Early Works Report Addendum

Bradford Bypass County Road 4 Early Works

September 6, 2022

APPENDIX A: Revised Detour Staging Drawing

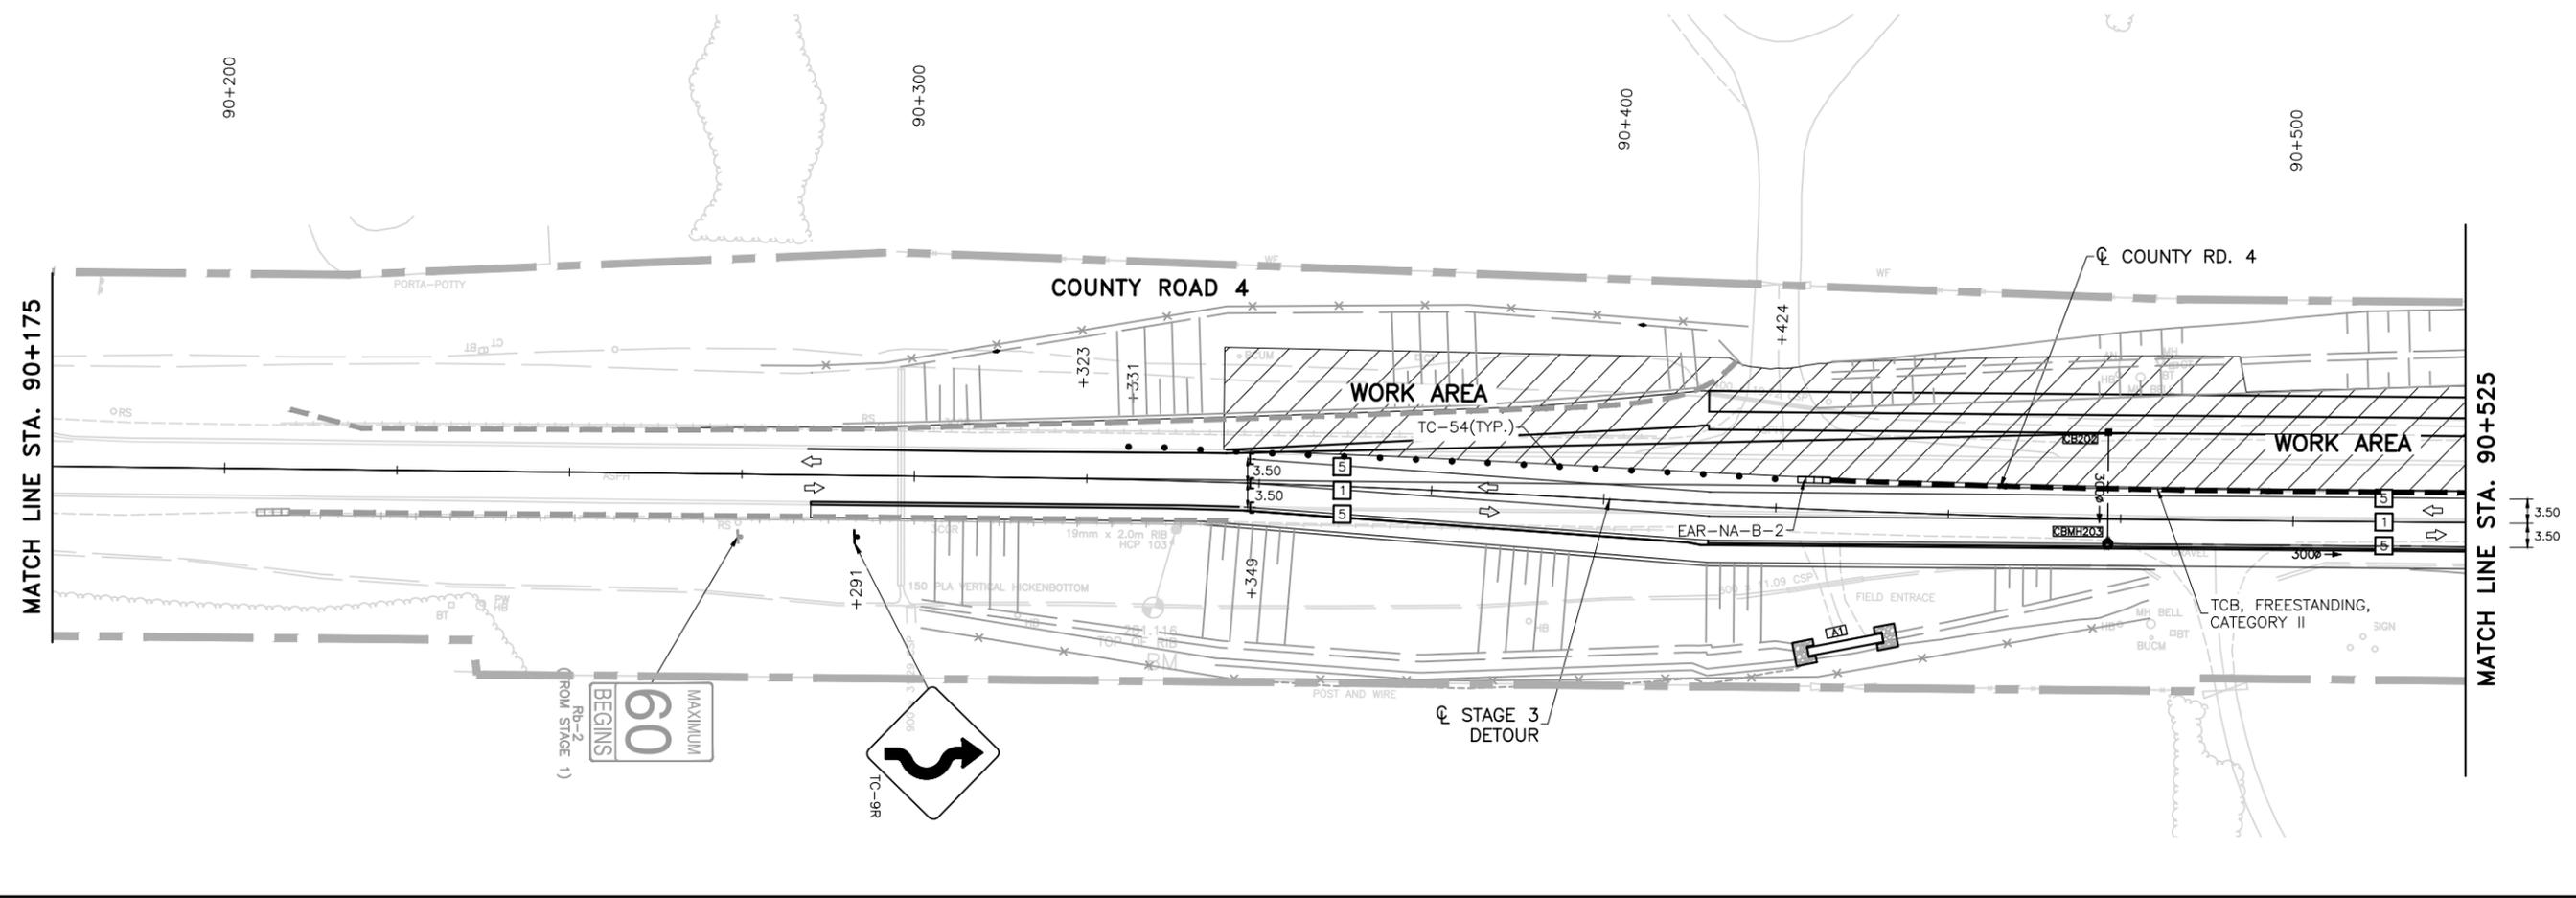
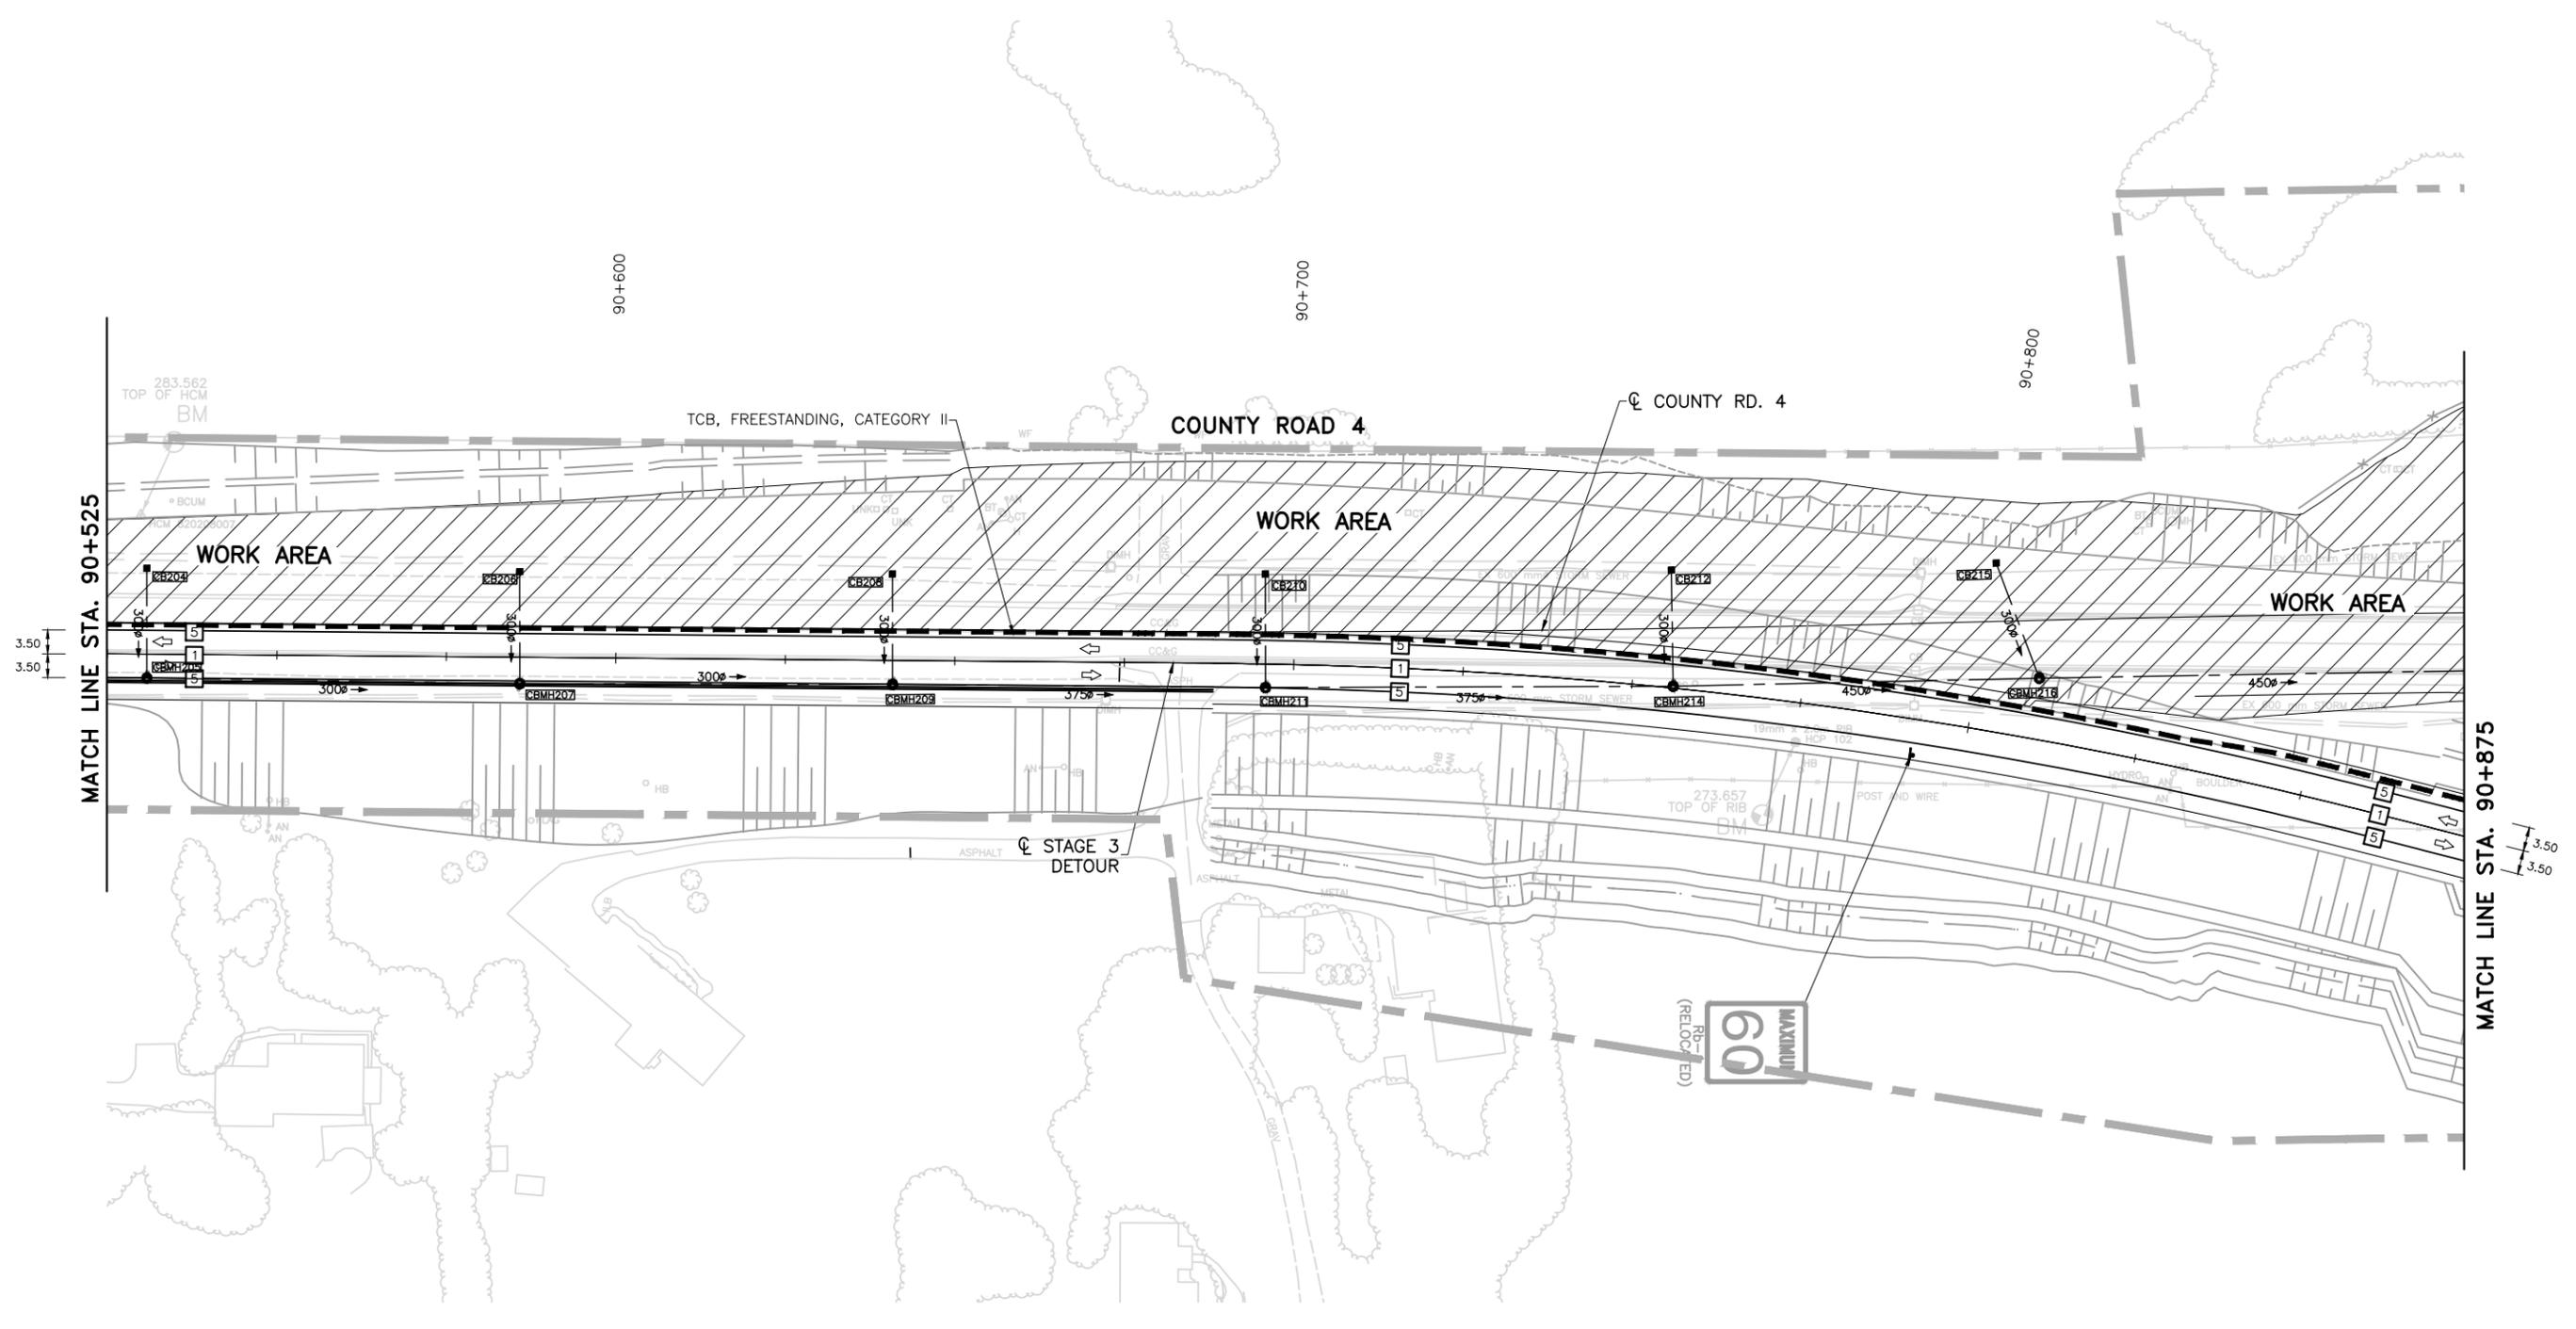
The original detour was designed in close proximity to the bridge work area and required temporary supporting walls, known as shoring, to facilitate the construction. Brennan-MH is proposing to shift the detour 16 meters to the west (at its farthest) from its planned location shown in the Early Works Report. By shifting the detour away from the bridge work area, the need for shoring is avoided, simplifying construction and reducing construction related noise from driving piles, required for the shoring walls, into the ground.

| STAGE 3B | |
| 1. CONSTRUCT COUNTY ROAD 4 UNDERPASS STRUCTURE. | • SHIFT NORTH BOUND AND SOUTH BOUND TRAFFIC ONTO STAGE 3 DETOUR |
| 2. CONSTRUCT AND COMPLETE REMAINING PORTIONS OF COUNTY ROAD 4 PAVEMENT AND STORM SYSTEM. | |
